Equipment Technical Bulletin

Stainless Steel Clamps Are Now Being Used on Large EPDM SnapHead Pump Tubes

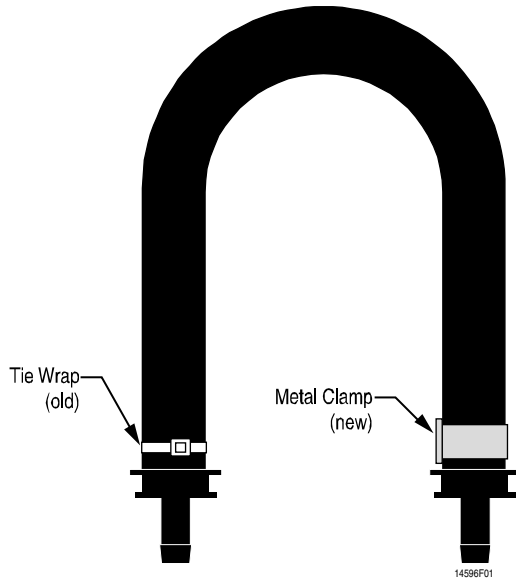
REASON / BACKGROUND

Tie wraps are not reliably holding the tube on the standard Summit 0.25" (6.35 mm) ID EPDM tube.

SOLUTION / ACTION

Stainless steel clamps are now being used to ensure reliable connections. The tube kit item number is the same (087900), and all new tube kits are being built with the stainless steel clamp.
